Subject: Westinghouse Response to Requests for Additional Information (RAIs) on  
WCAP-17577, Rev. 1

# WESTINGHOUSE TOPICAL REPORT REVIEW

RAI Response Number: WSTM-001-NP

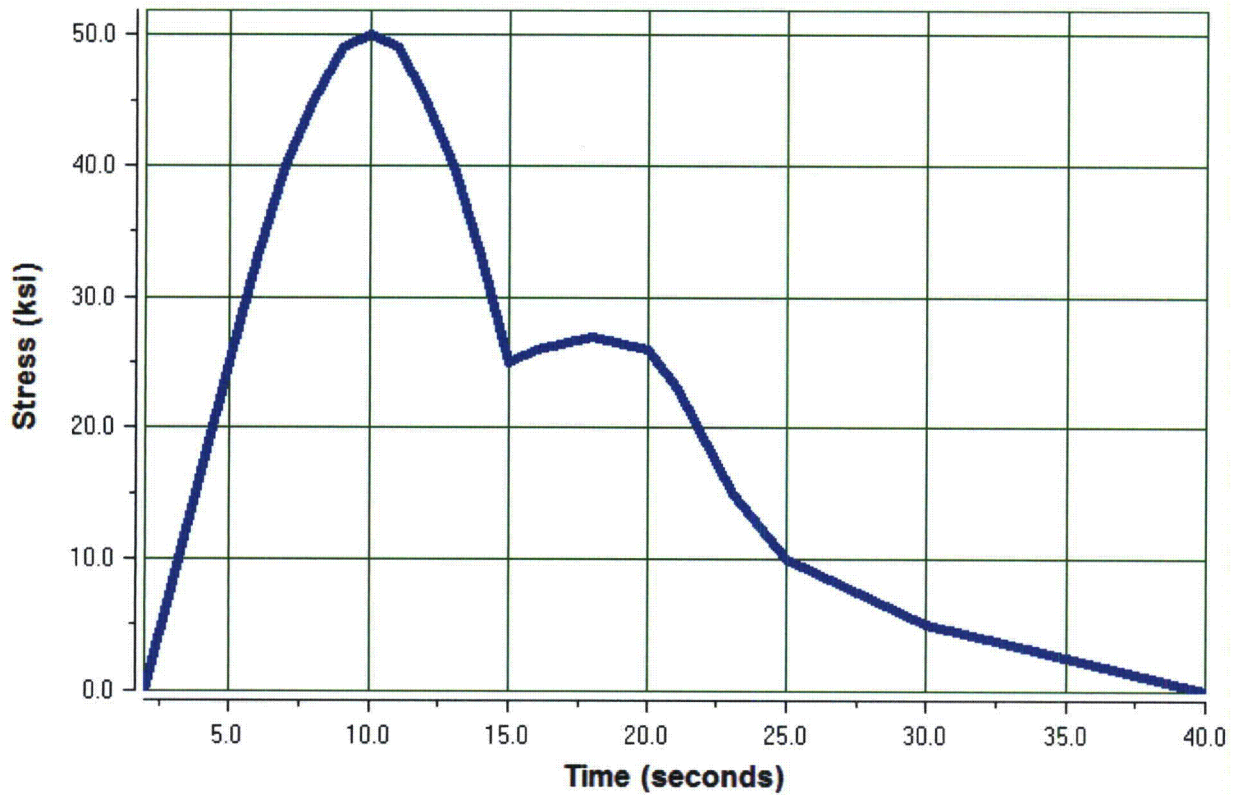
In Figure 4-4, the stress filter check was used for peak selection option process. The staff is requesting the applicant to explain the process to ensure the critical (maximum stress for peak, minimum stress for valley) points are retained for both NB-3600 and NB-3200.

The following example reviews how the stress filter can apply to a typical case representing a redundancy due to [

] <sup>a,c</sup> This example is intended to provide an understanding of the step-by-step functionality of the stress filtering process [
